Burlington Development Review Board

Tuesday, August 4, 2026, 5:00 PM

- 5.1. ZP-26-293; 227 North Champlain St (RM, Ward 2) Tyler Bolles**
Proposed replacement of an existing garage with a two-story accessory dwelling unit.

To: Development Review Board
From: Mary O'Neil, AICP, Principal Planner
Date: August 4, 2026
RE: 227 North Champlain Street: ZP-26-293

PROPOSED ELEVATIONS

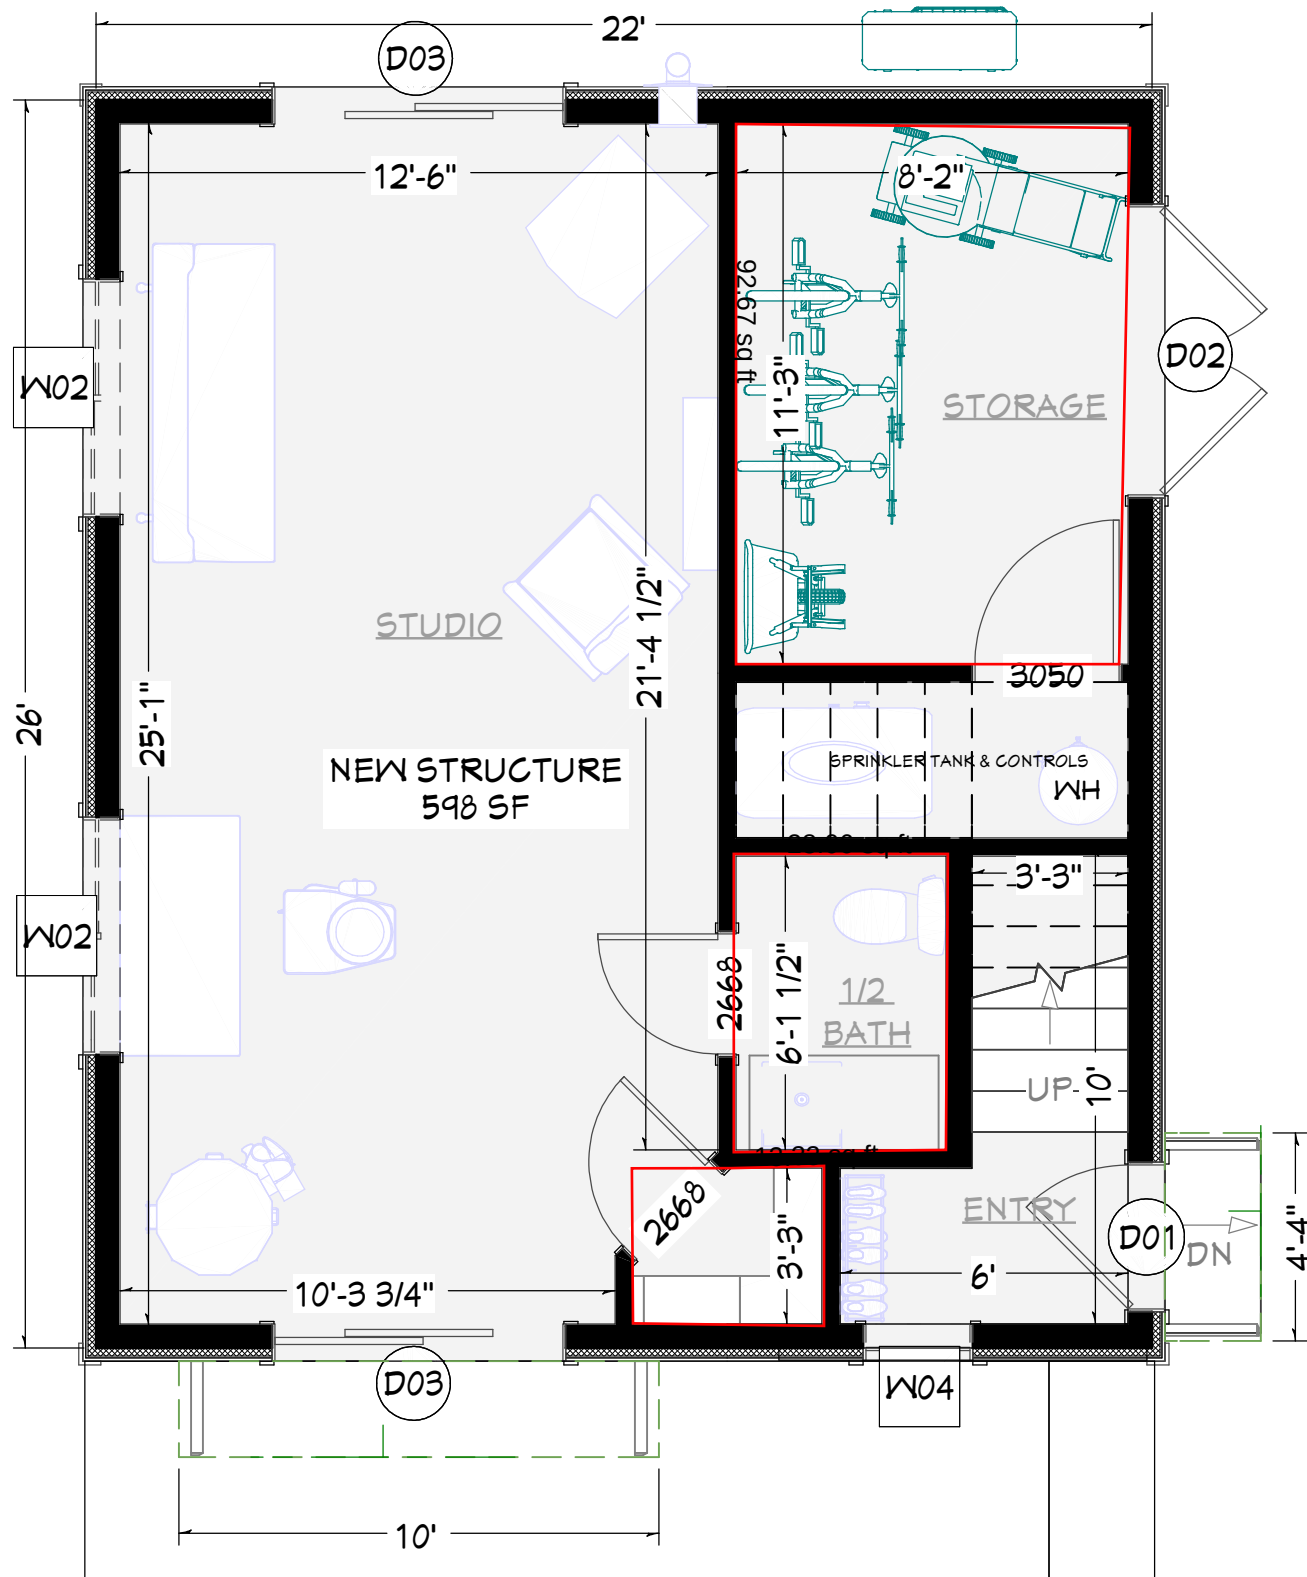
Floor plans define installation of a wood stove and a second floor airhandler. A compressor is illustrated on Sheet 4, west elevation; and the Sheet 5, floor plan.

Floor plans show trash within the storage room. An air handler is illustrated on the interior/second floor; a condensing unit at the west elevation. The location of the mailbox for the ADU is illustrated on the east elevation. The applicant must connect with the fire marshal to establish an E-911 address for the new residential unit. **Affirmative finding as conditioned.**
